Change Order

Ketchum Fire Station #1
107 Saddle Road, Ketchum, ID

Change Order Number: 008
Date: August 11, 2021

See attached spreadsheet of seven items.

- A7.00 – ROOF PLAN
- A7.22 – DETAILS ROOF
- A7.23 – DETAILS ROOF

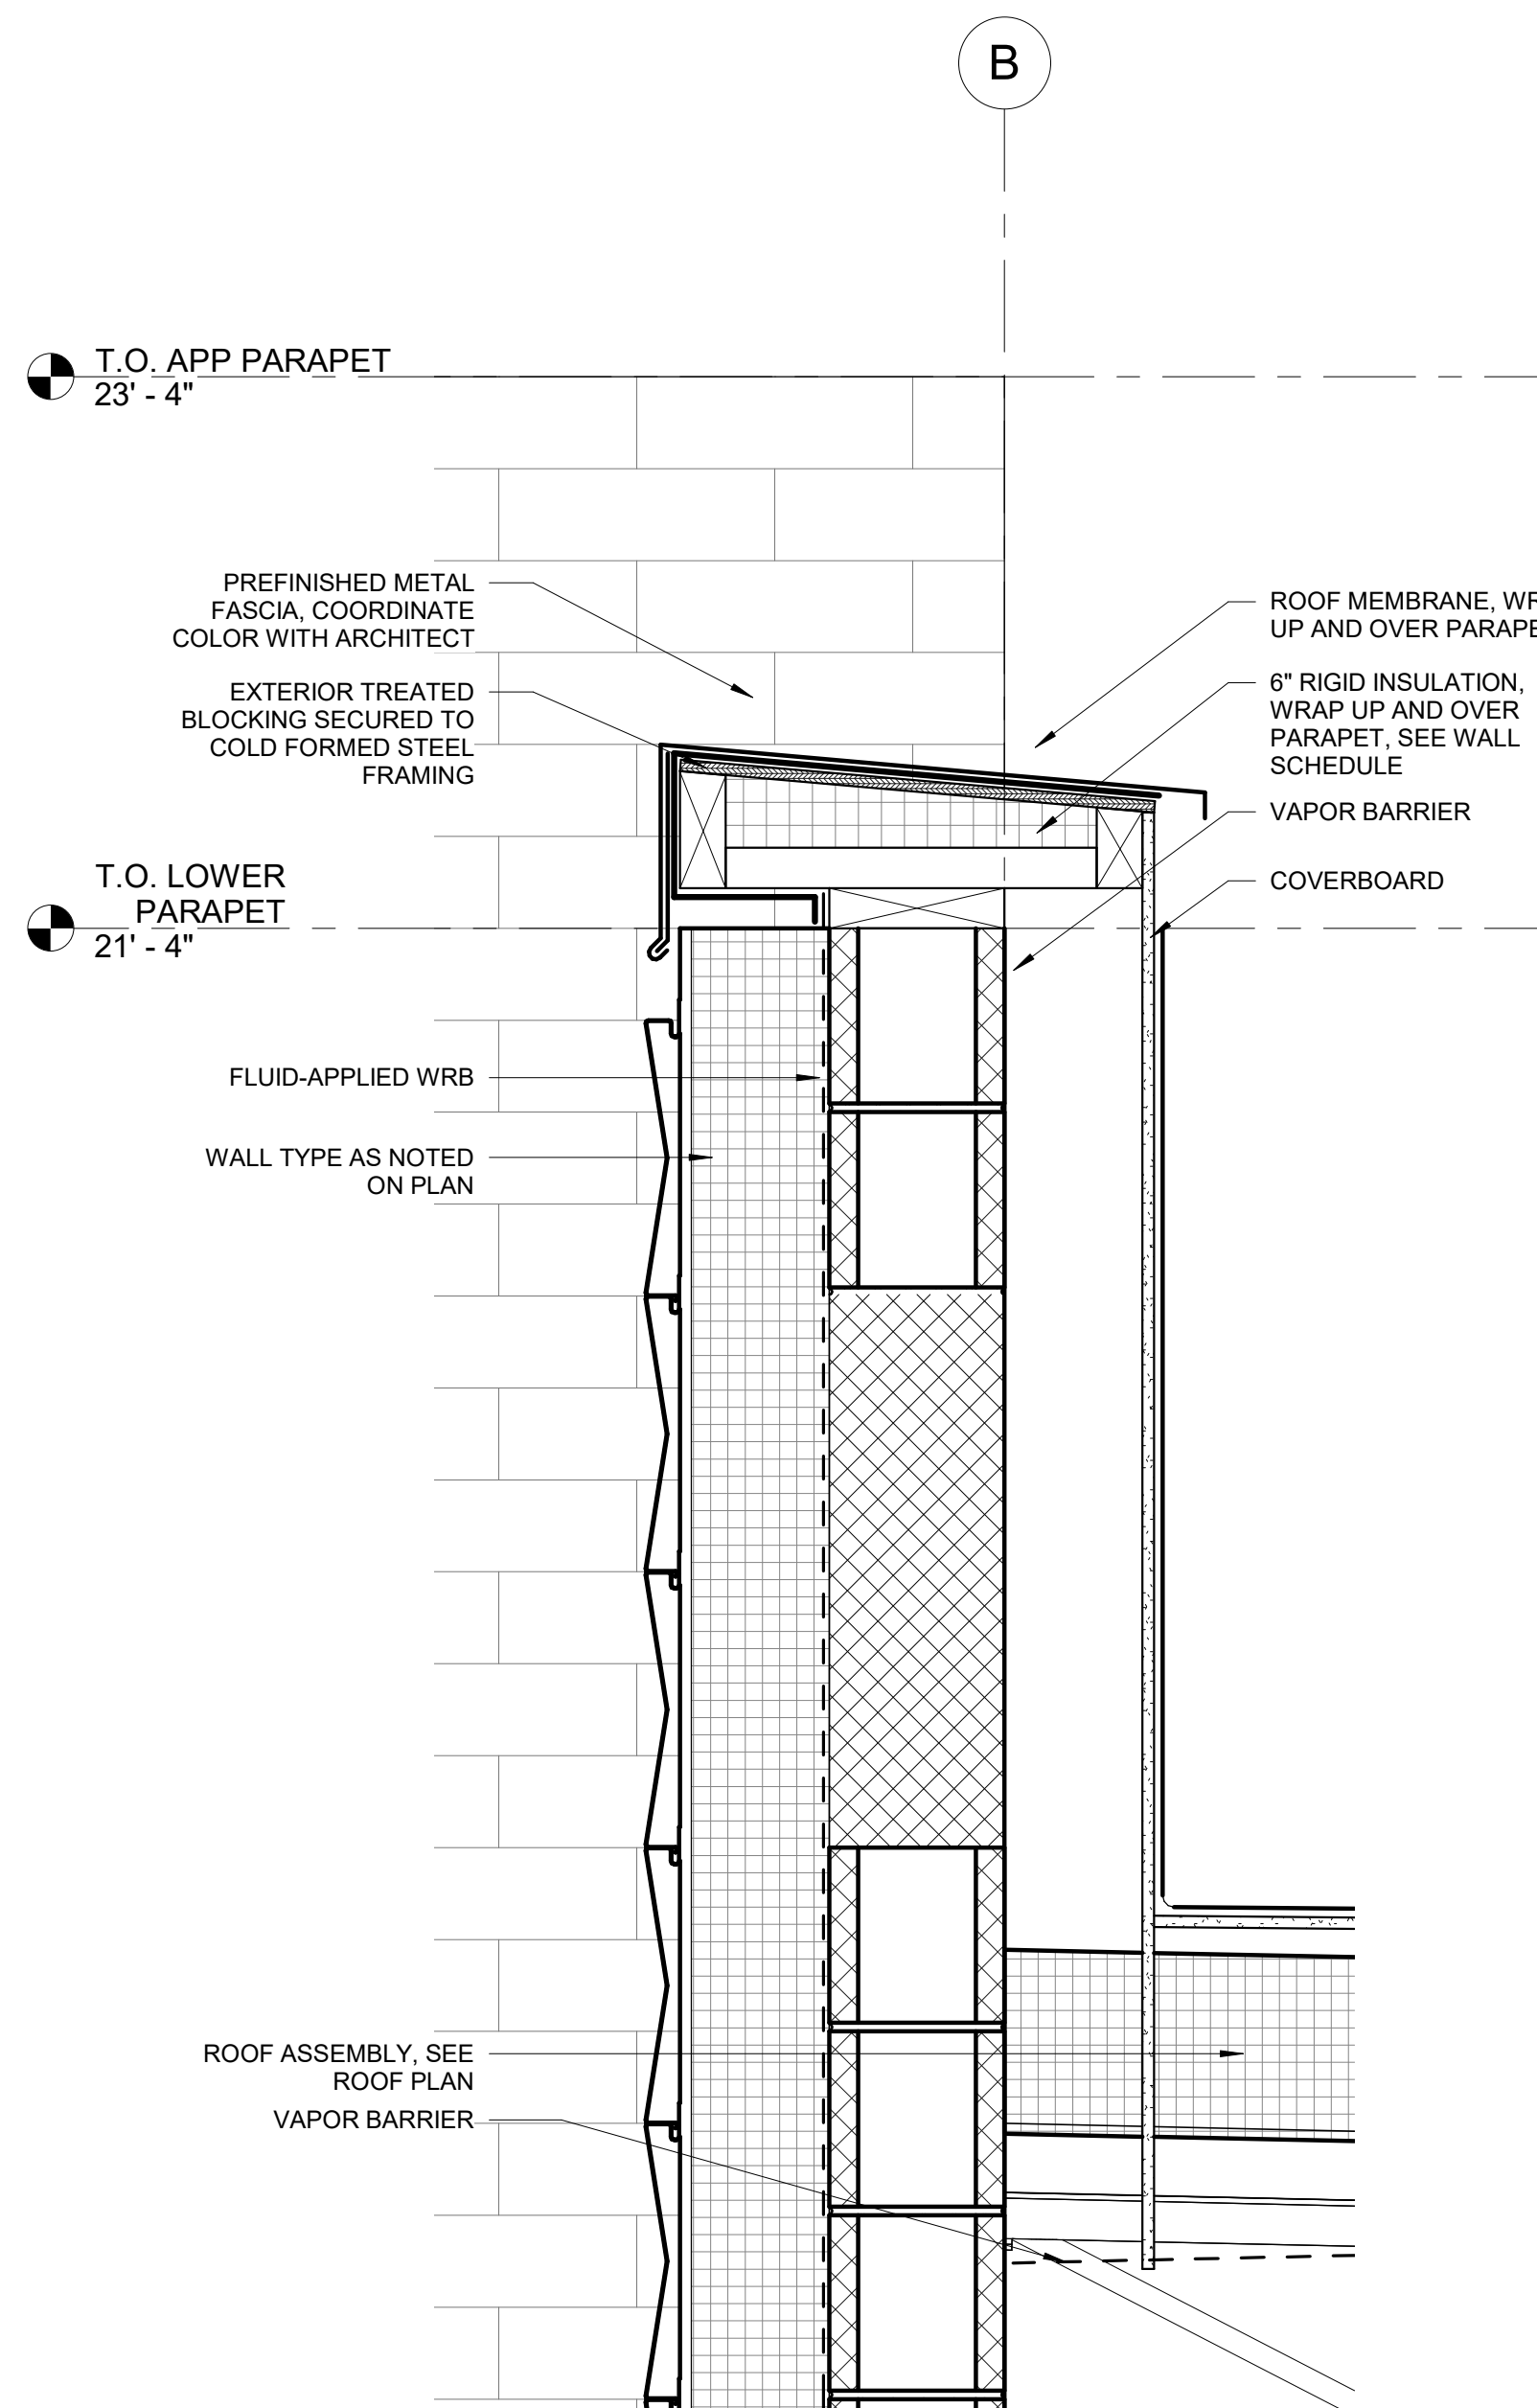
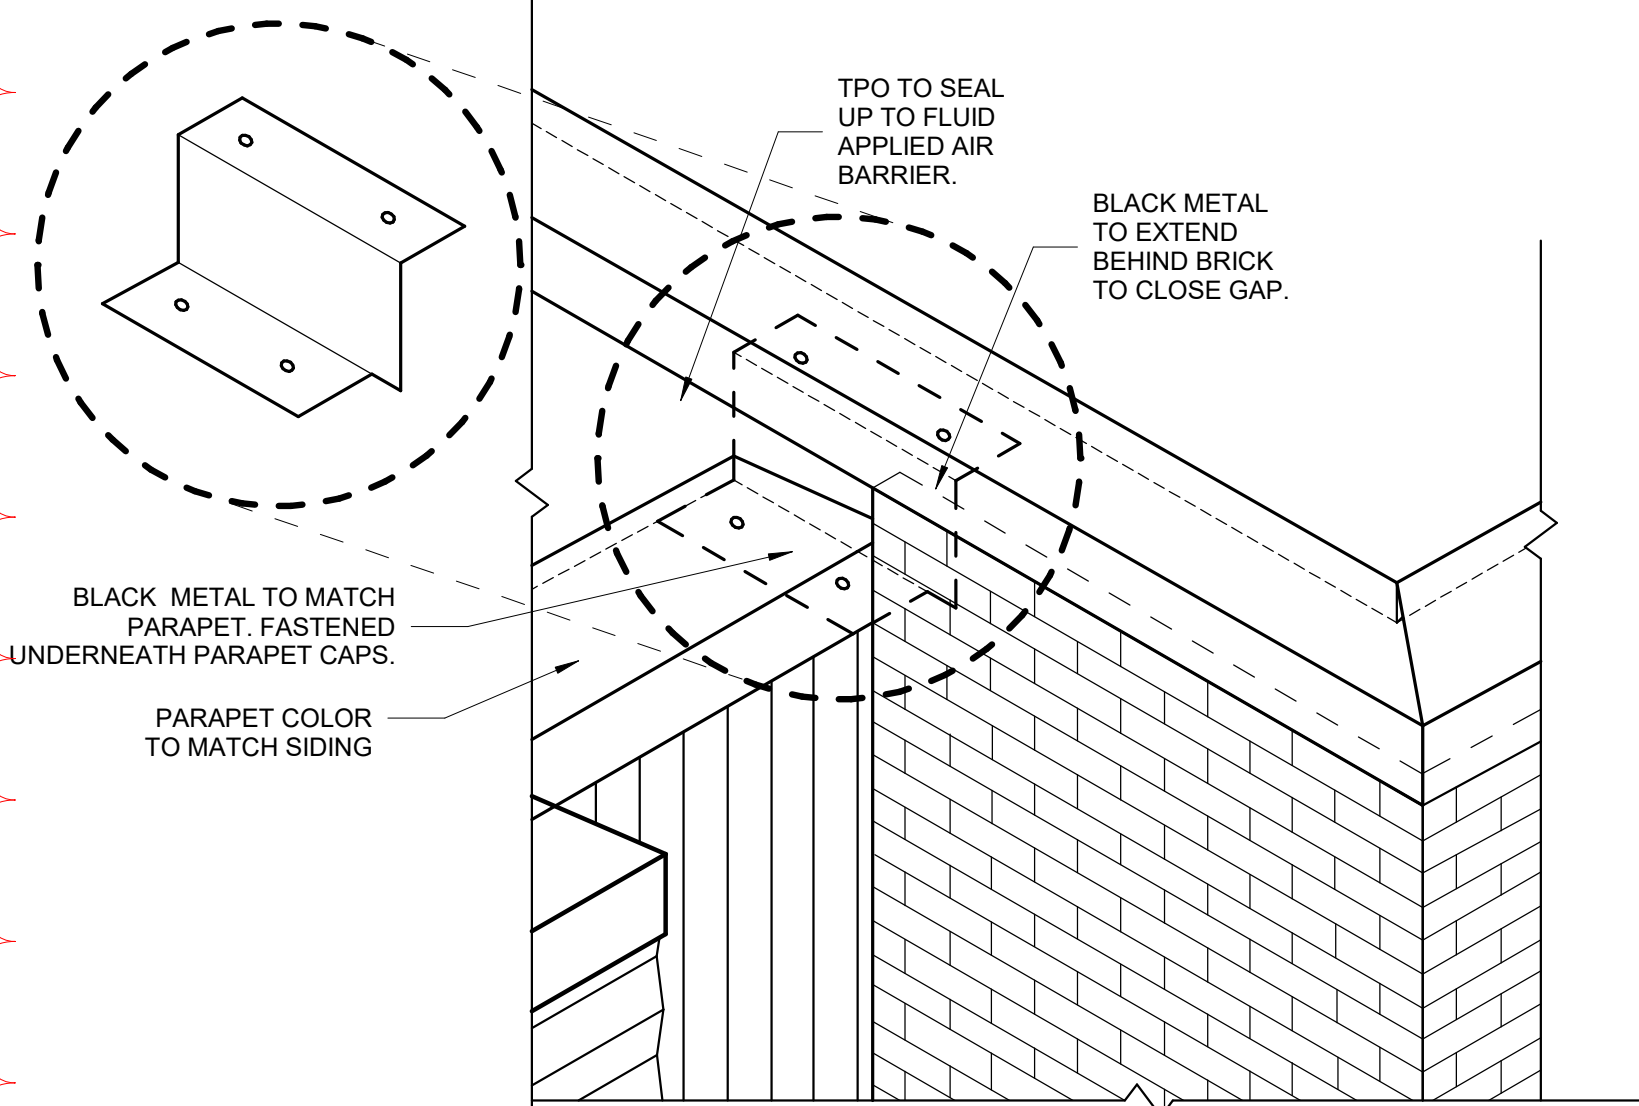
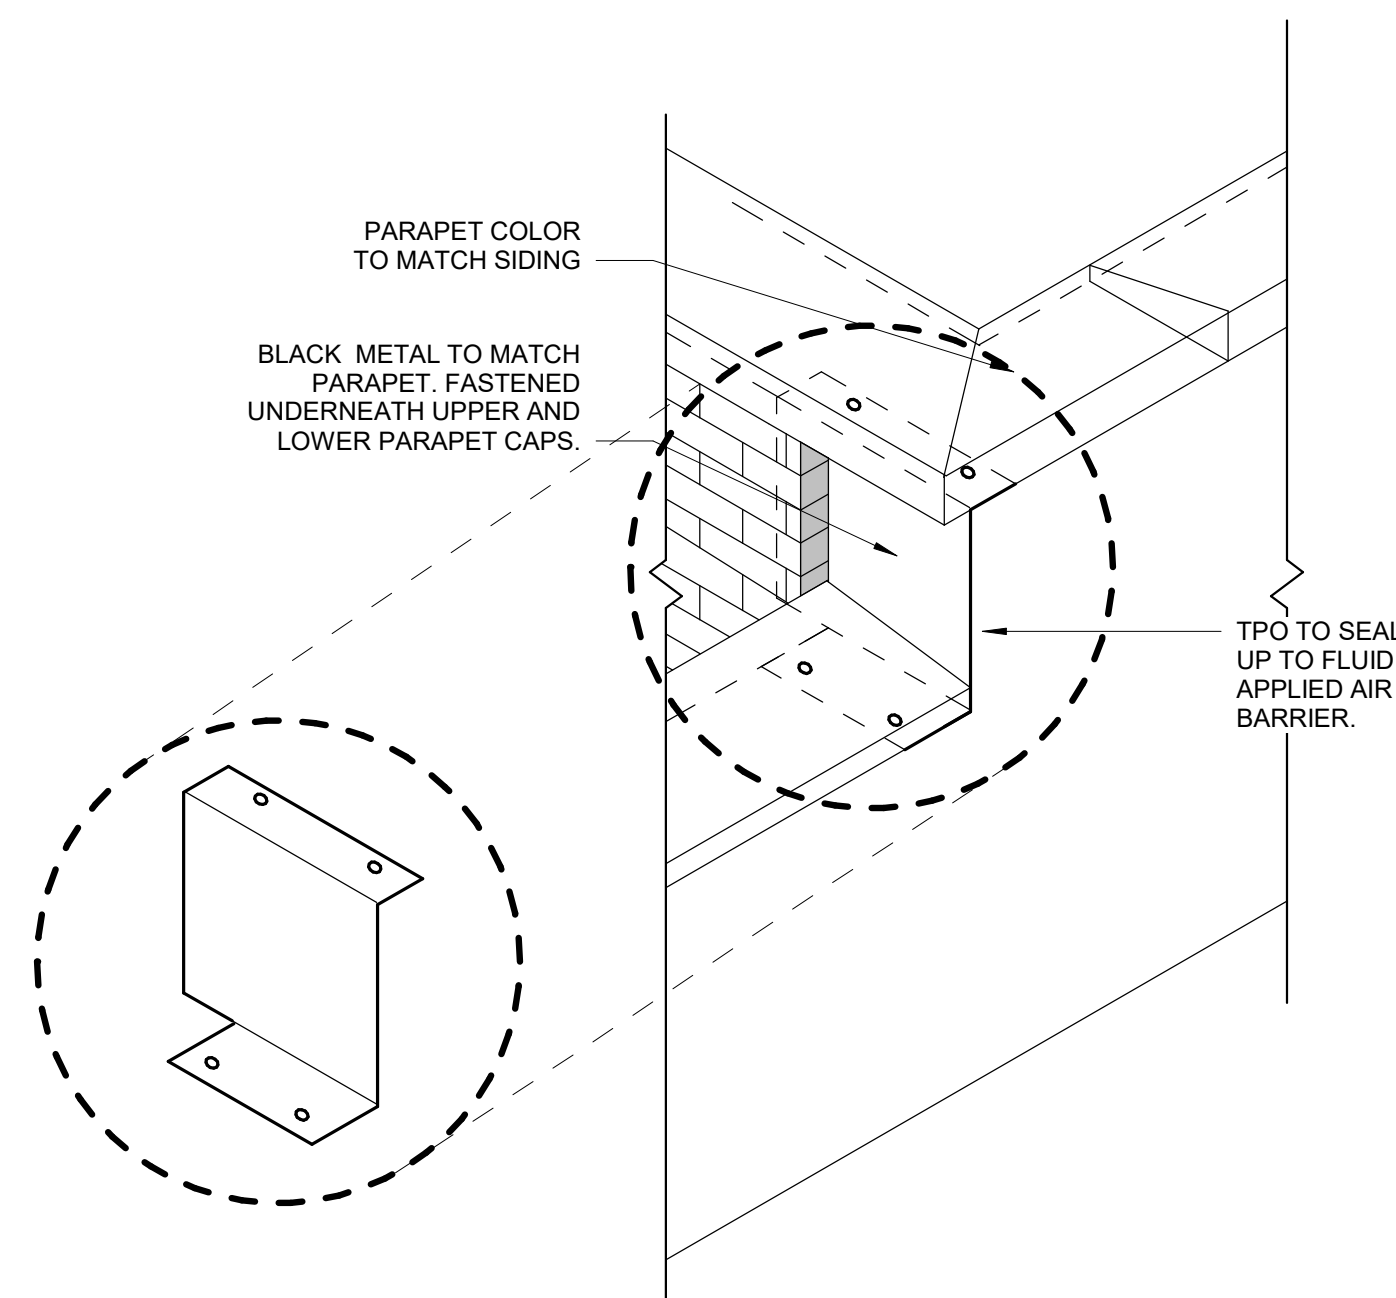
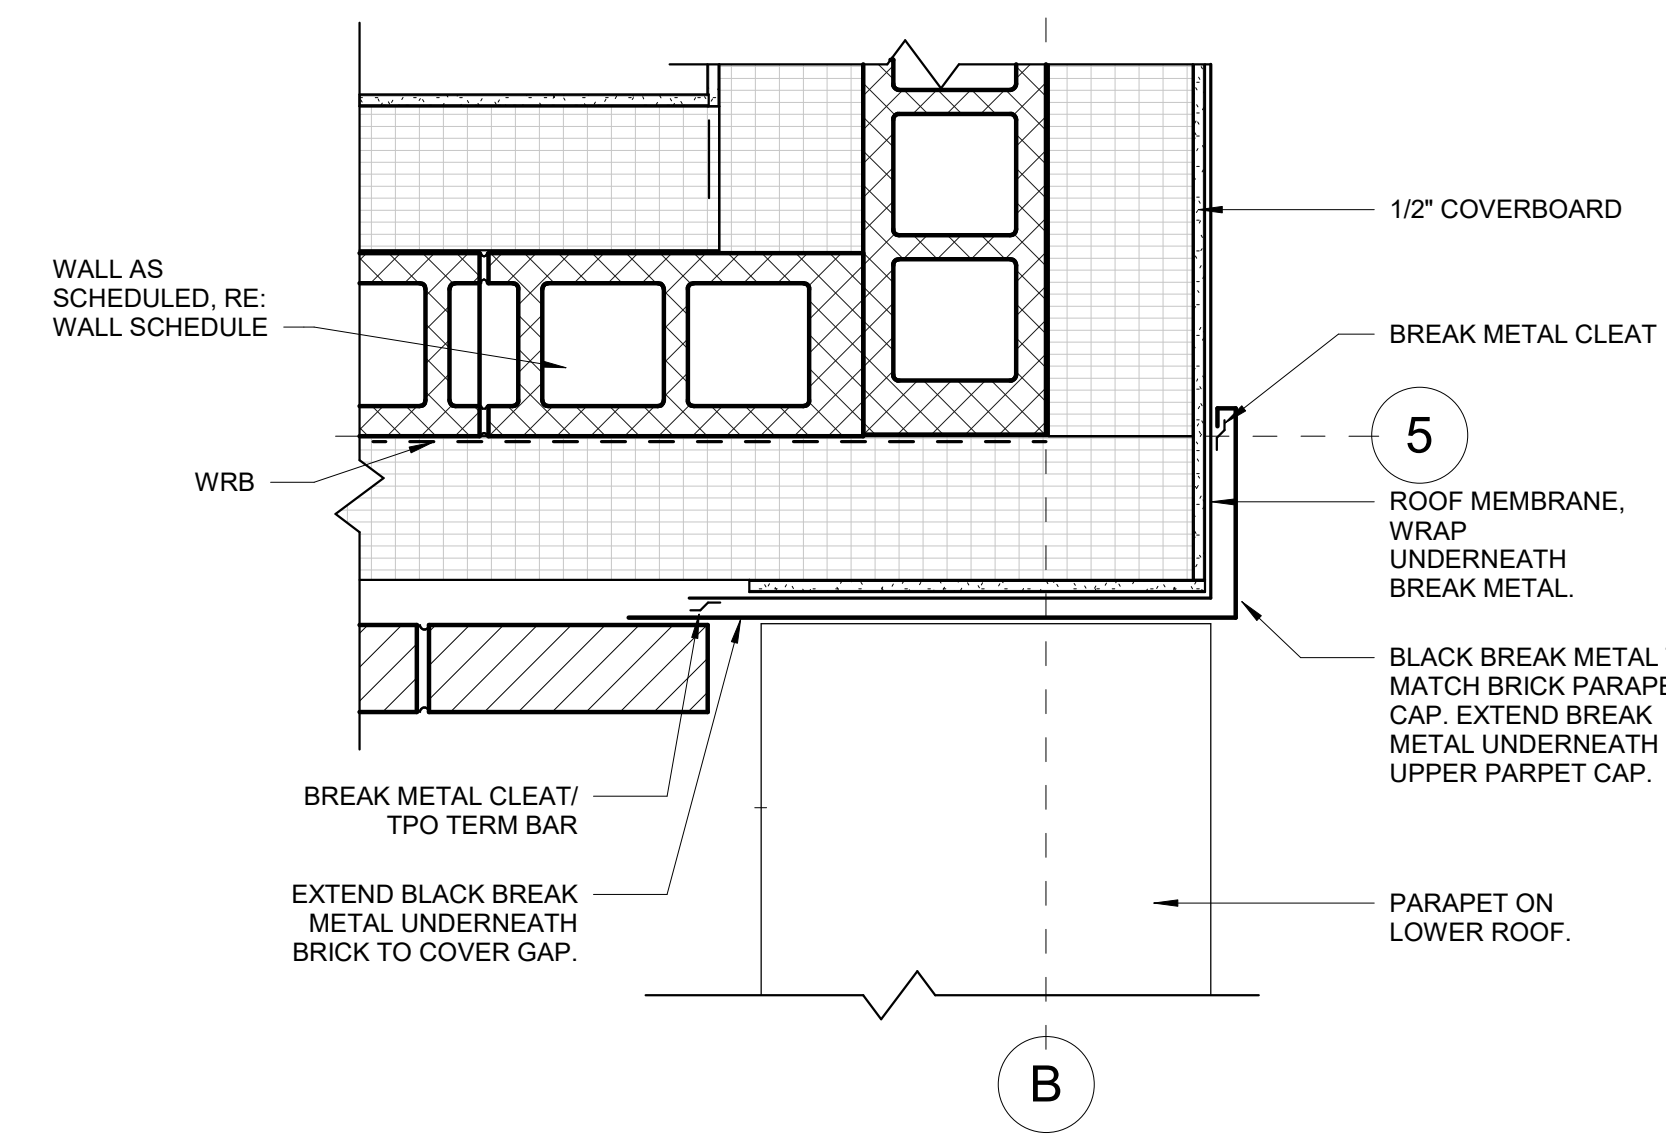
- 1) A3.00 – EXTERIOR ELEVATIONS
 - a) #1 – EXTERIOR ELEVATION – EAST
 - i) ADDED DETAIL CALL OUT.
 - b) #4 – EXTERIOR ELEVATION – WEST
 - i) UPDATED PARAPET HEIGHT.
 - ii) ADDED DETAIL CALL OUTS.
- 2) A7.00 – ROOF PLAN
 - a) ADDED FOUR DETAIL CALLOUTS FOR UPDATED DETAILS ON SHEETS A7.22 – DETAILS ROOF AND A7.23 – DETAILS ROOF.
- 3) A7.22 – DETAILS – ROOF
 - a) ADDED DETAIL #9 – PLAN VIEW PARAPET DEAIL @ GRIDS G & 5.
- 4) A7.23 – DETAILS - ROOF
 - a) ADDED DETAIL #3 – ISO PARAPET DETAIL @ GRIDS B & 2N.
 - b) ADDED DETAIL #4 – ISO PARAPET DETAIL @ GRIDS 5 & B.
 - c) ADDED DETAIL #5 – PLAN VIEW PARAPET DETAIL @ GRIDS B & 5.
 - d) ADDED DETAIL #6 – PARAPET PLAN DETAIL @ GRIDS G & 1.
 - e) ADDED DETAIL #7 – ISO PARAPET DETAIL @ GRIDS G & 1.

DESCRIPTION:	Per ASI #10- Furnish and install additional Vapor Retarder, Roof Insulation, DensDeck, Install new TPO Wall Flashings at modified wall area, install metal wall caps
DRAWINGS:	Per ASI #10- Wall between Gridlines B & G, Revised Drawings 6/16/2021 A7.23 Added Details #3,#4,#5,#6,#7
